GROUP BOD	MODEL 2014~2015MY Sorento (XMa)
NUMBER 117 (REV 1, 03/17/2016)	DATE February 2016

TECHNICAL SERVICE BULLETIN

SUBJECT: COMBINED TSB /SERVICE ACTION: EXTERIOR REAR DOOR HANDLE TRIM CAP(S) REPLACEMENT (SA 200)

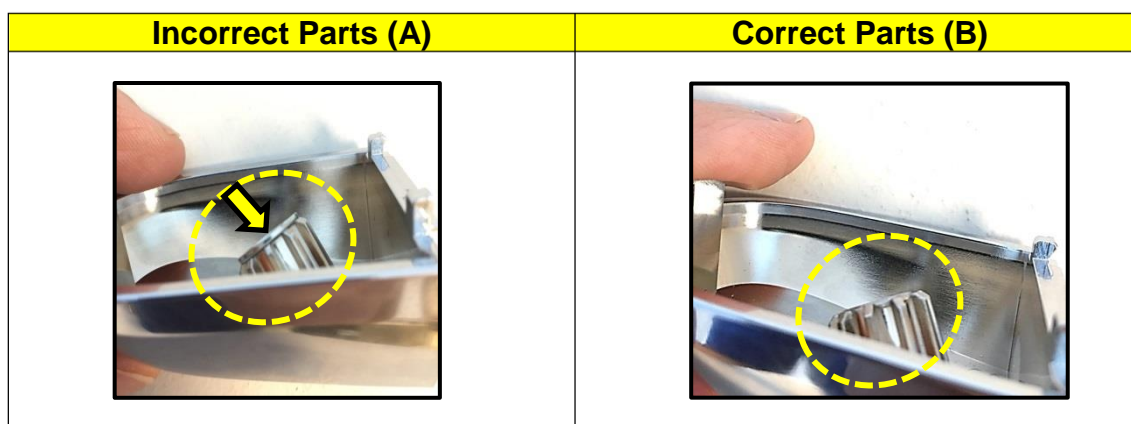
Some dealers may have received the incorrect parts for SA200 (P/N 83652 1U010QQK and 83662 1U010QQK, COVER-RR DR O/S HDL, RH and LH). The incorrect parts (A) will have an additional flange that will cause an interference with the handle base when installed. The correct parts do not have the additional flange (B).
